**SITE PLAN REVIEW SHEET  
ENVIRONMENTAL VARIANCE REQUEST ONLY**

**CASE:** SP-2019-0417D

**PROJECT NAME:** Additional 300K Ground Water Storage Improvements 360

**ENVIRONMENTAL COMMISSION MOTION 20200520-006a**

## SITE DIMENSION PLAN

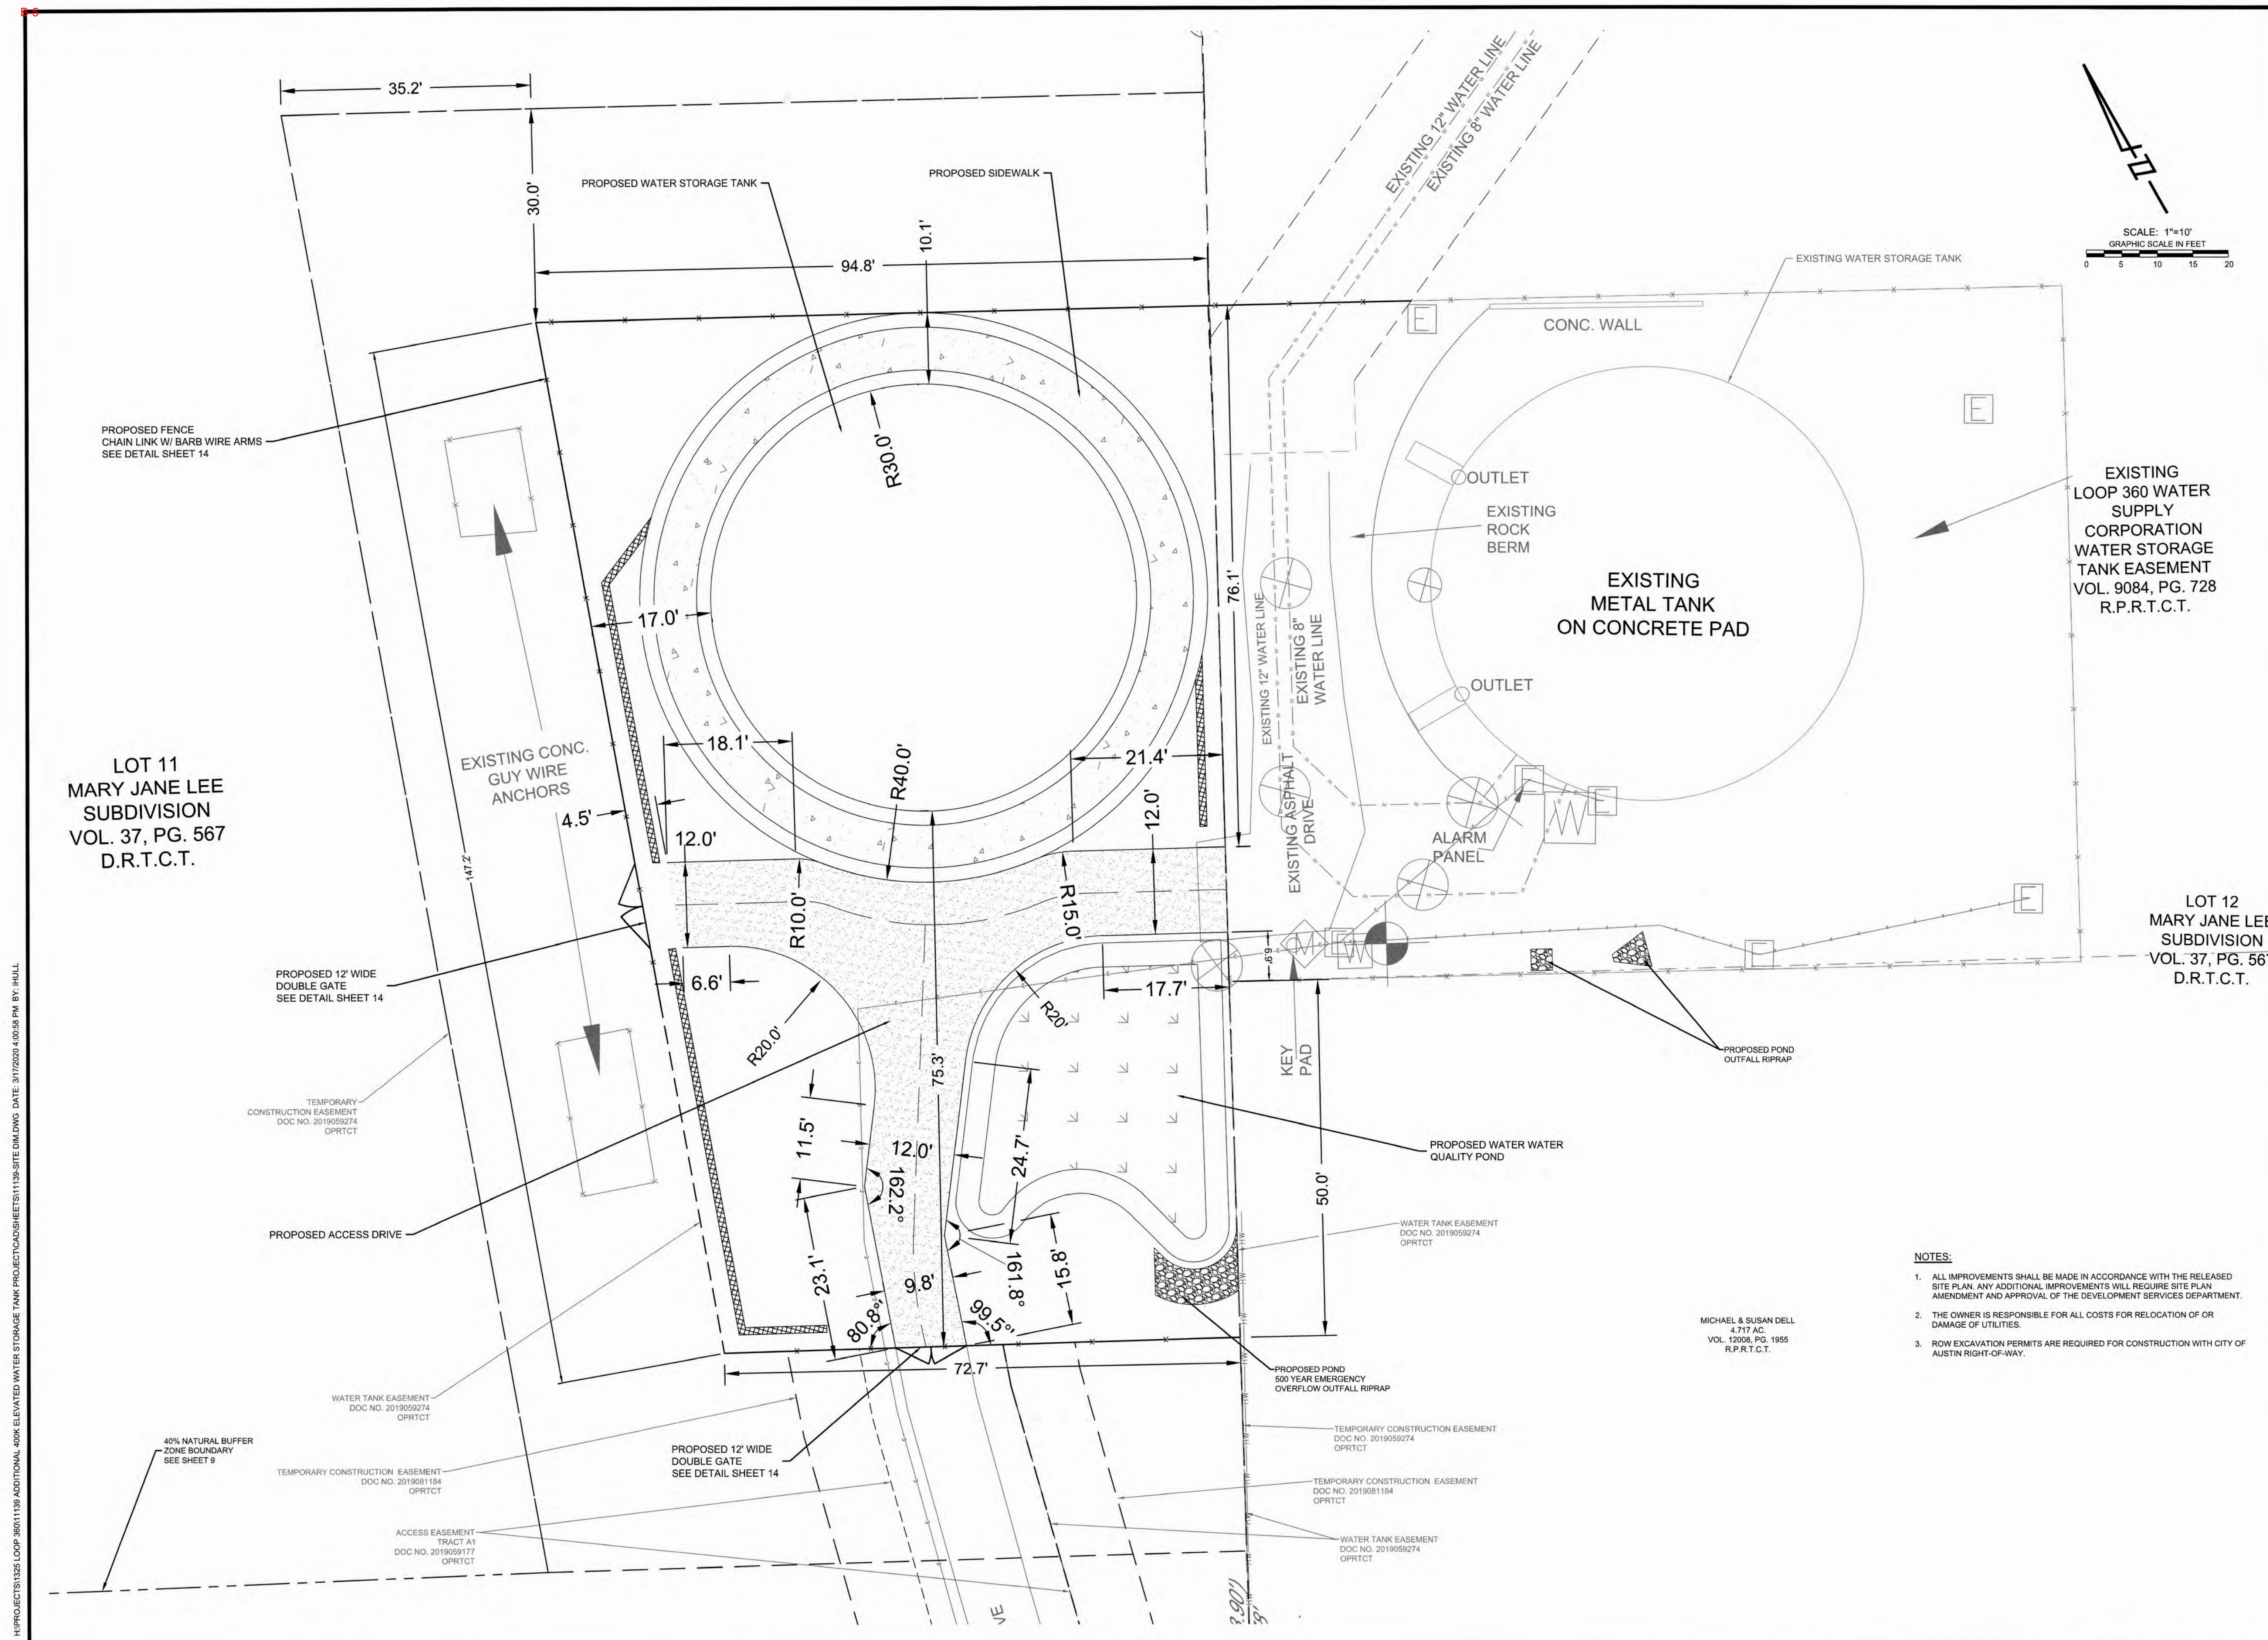
cannot be expanded because the tank must be designed to fit within the allotted easement. Within this easement, there is also surface area required to provide a sidewalk / concrete trickle channel to convey overflow drainage towards the pond and an earthen berm that will prevent off-site surface water flows onto the site. Furthermore, the allotted easement cannot be expanded as there are two existing guy wire anchors for the communication tower immediately adjacent to the west of the project site. Options to adjust the location or configuration of the proposed tank are infeasible based on the site characteristics unique to this property and based on the required design specifications for the proposed tank. See Staff Exhibit 1 – Proposed Site Plan.

CUT/FILL EXHIBIT

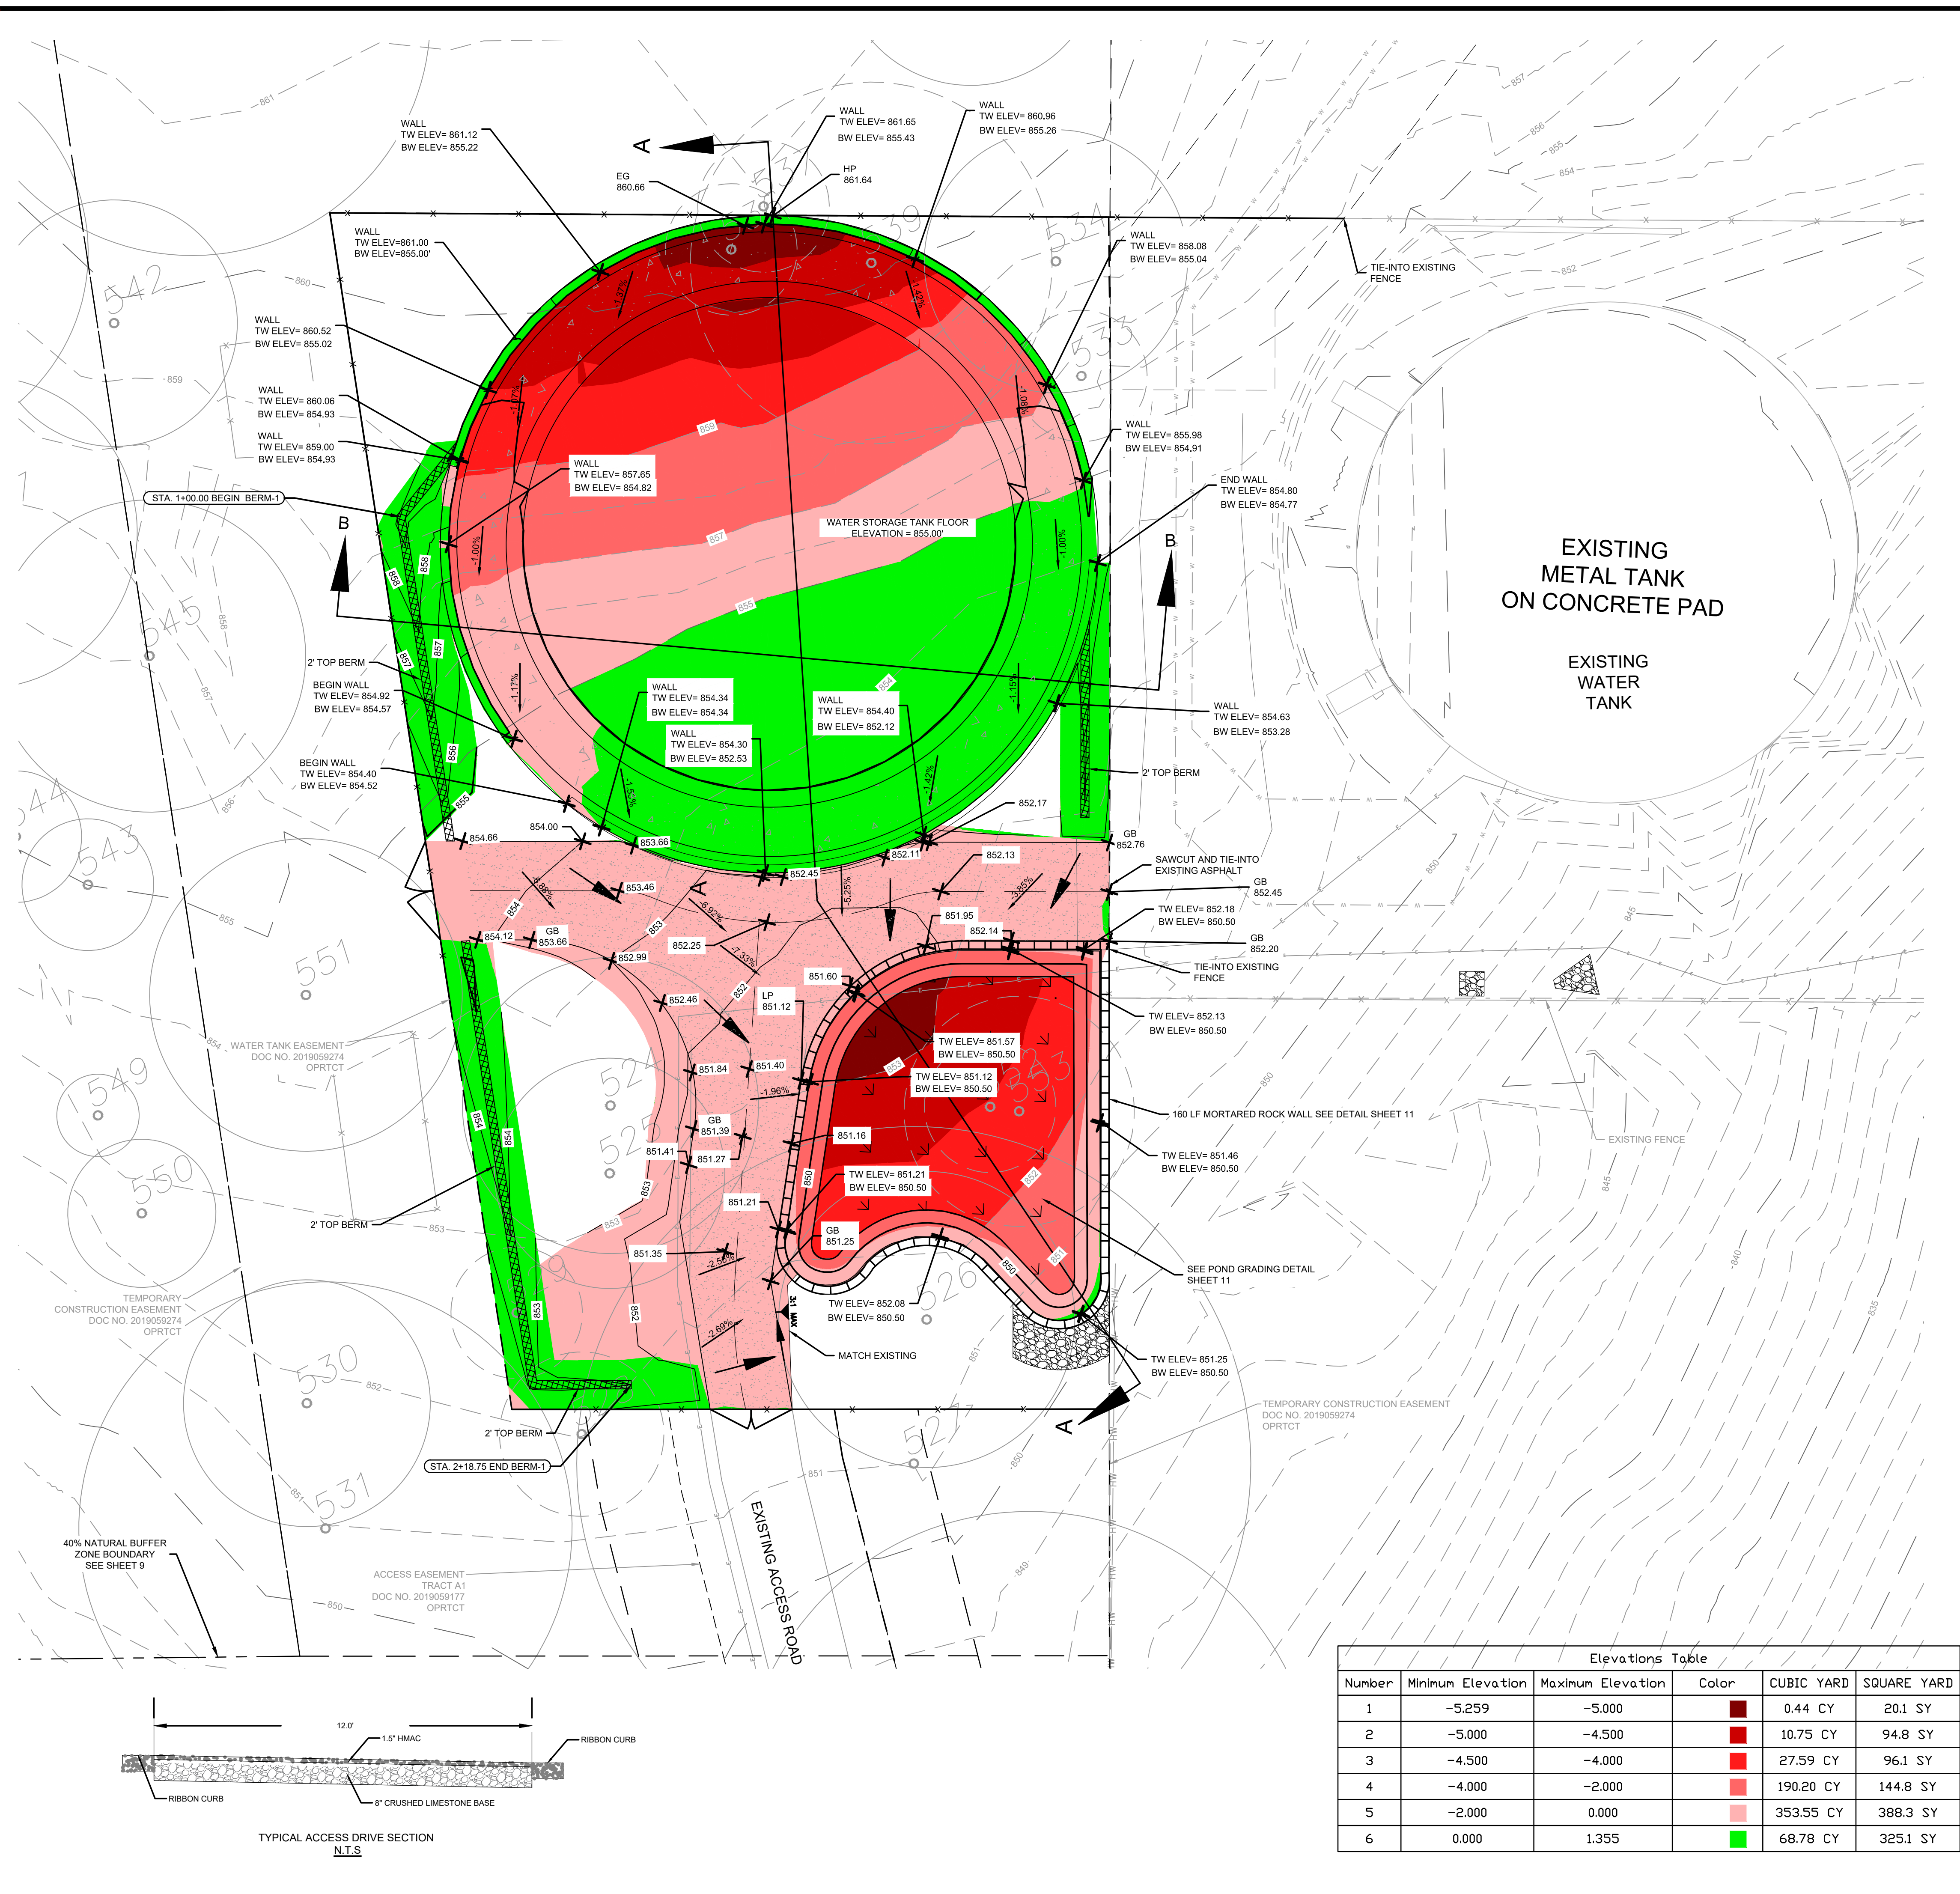
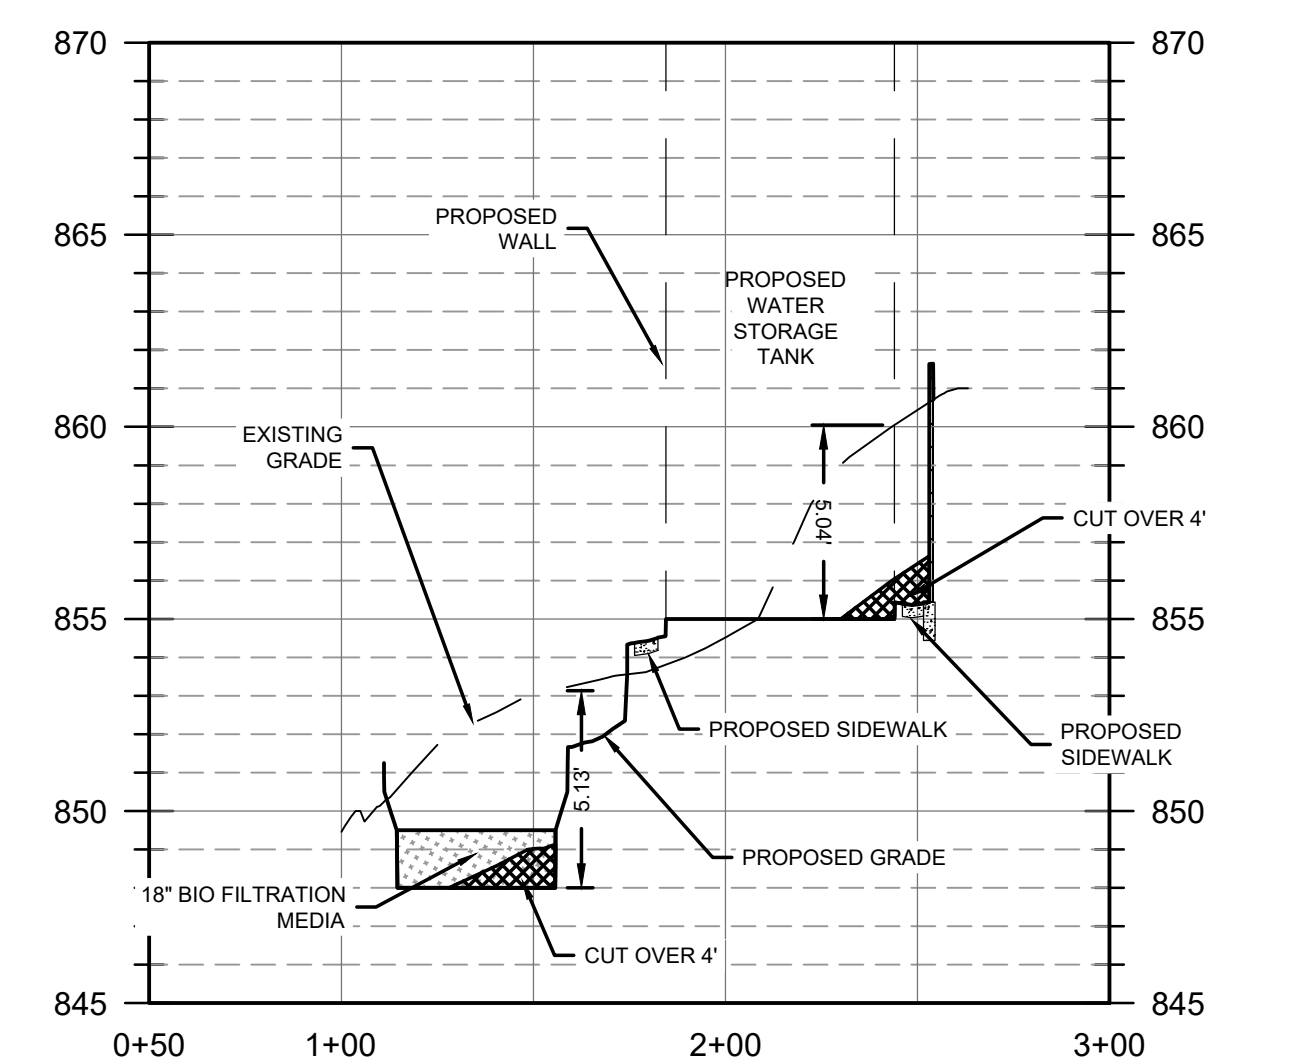
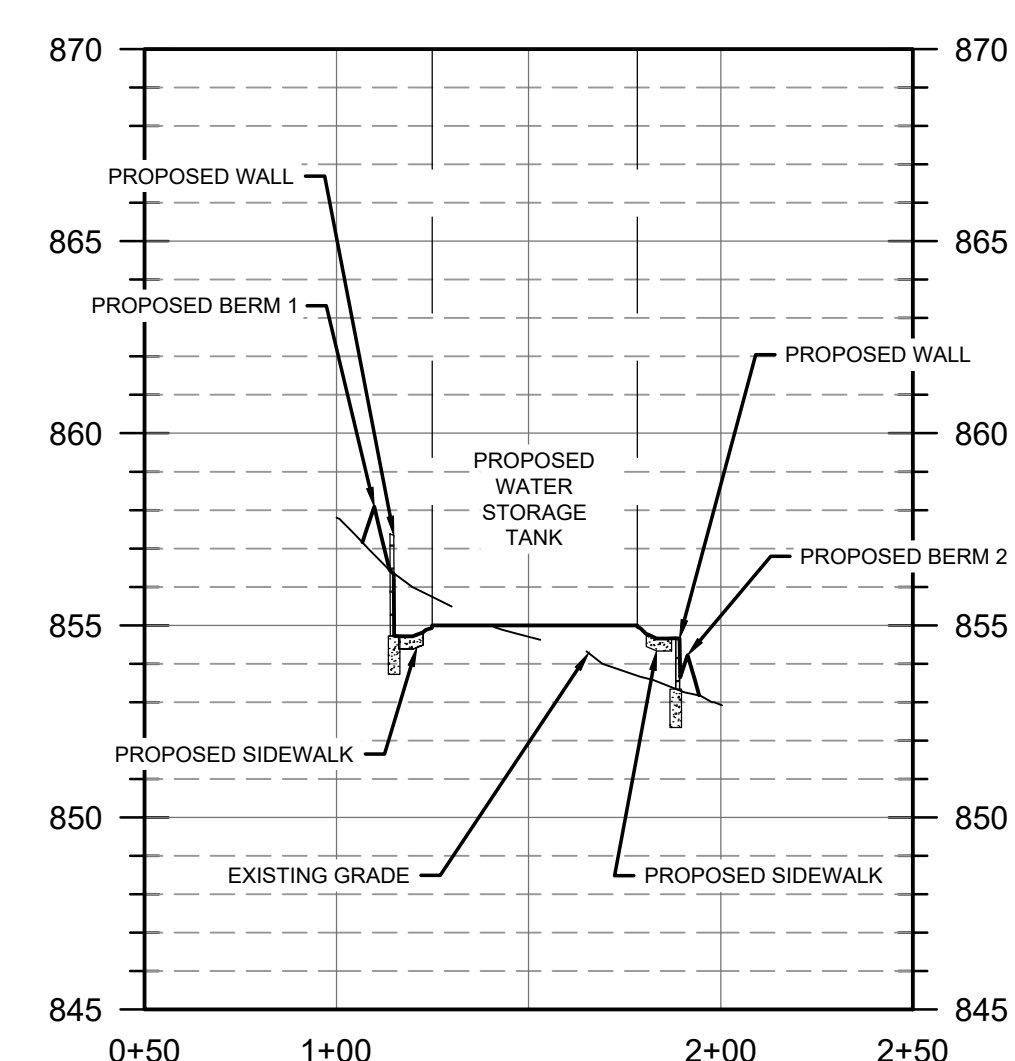
LDC 25-8-341 states that cut may not exceed 4 feet of depth. Due to the required location and overflow elevation of the proposed tank and associated water quality rain garden, a cut of up to 5.259 feet is required. See Exhibit A - Variance Request Letter for further explanation.

Due to the required storage capacity, location, and overflow elevation of the proposed ground water storage tank, a cut of up to 5.259 feet is required. The Project is being constructed by the Loop 360 Water Supply Corporation to improve its water storage capacity capabilities to its customers. The location of the storage tank is required due to the allotted area provided by the property owner, LIN Television of Texas, L.P. (KXAN) to the Corporation for all proposed improvements, including drives, water quality controls, and grading. Additionally, the location of all proposed improvements ensures the preservation of as many trees (8" and larger) as possible.

Design of the required water quality rain garden requires cut of up to 5.13 feet in order to meet the rain garden requirements outlined in ECM appendix R-11, and Stormwater Management requirements in DCM chapter 8. The position and elevation of the pond is also required because it needs to accept flows from the site, while being able to outflow at the proper location, and preserving as many trees as possible. Also note that all cut over 4 feet within the rain garden will be filled with biofiltration media.
